PRODUCT CHANGE NOTICE

1. TITLE Dimensions, SMD Carrier		2. DOCUMENT NUMBER FV5-C-21-0005
		3. DATE April 7, 2021
4. MANUFACTURER AND ADDRESS International Rectifier HiRel Products, Inc 205 Crawford Street Leominster, MA 01453		5. MANUFACTURER PART NUMBER See below for IR Part Numbers
		6. BASE PART NA
		7. NATIONAL STOCK NUMBER (NSN) NA
8. CAGE 69210	9. EFFECTIVE DATE April 7, 2021	10. GOVERNMENT NUMBER NA
11. POINT OF CONTACT Manufacturer's Representative or Account Specialist (978) 534-5776		12. DRAWING NUMBER NA
		13. SPECIFICATION NUMBER MIL-PRF-19500

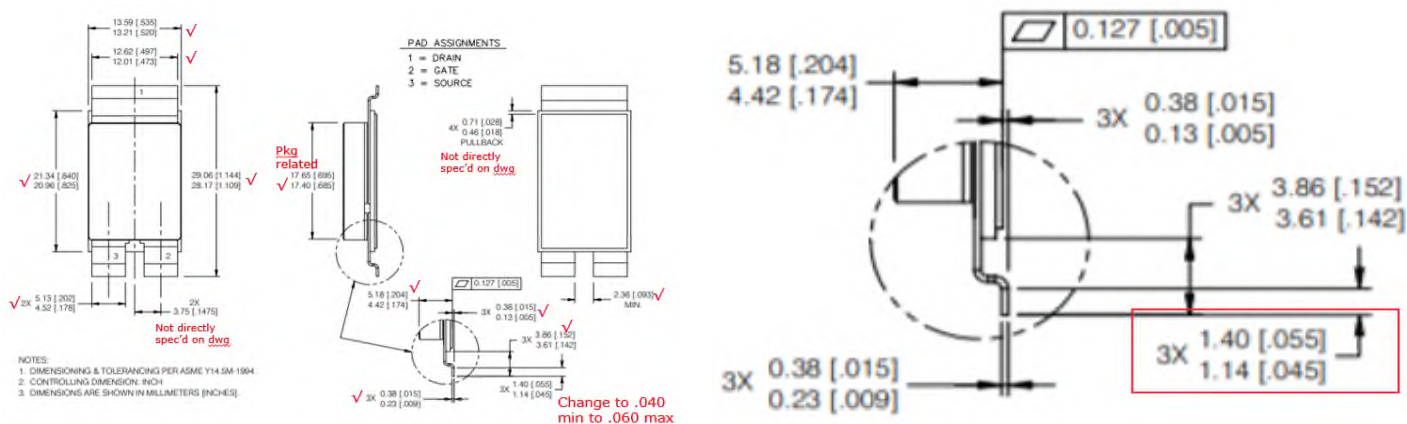
Change the lead form (bend) of the carrier from loop to flat

Change the foot length (dimension RS3) from 0.045"- 0.055" to 0.040" to 0.060"
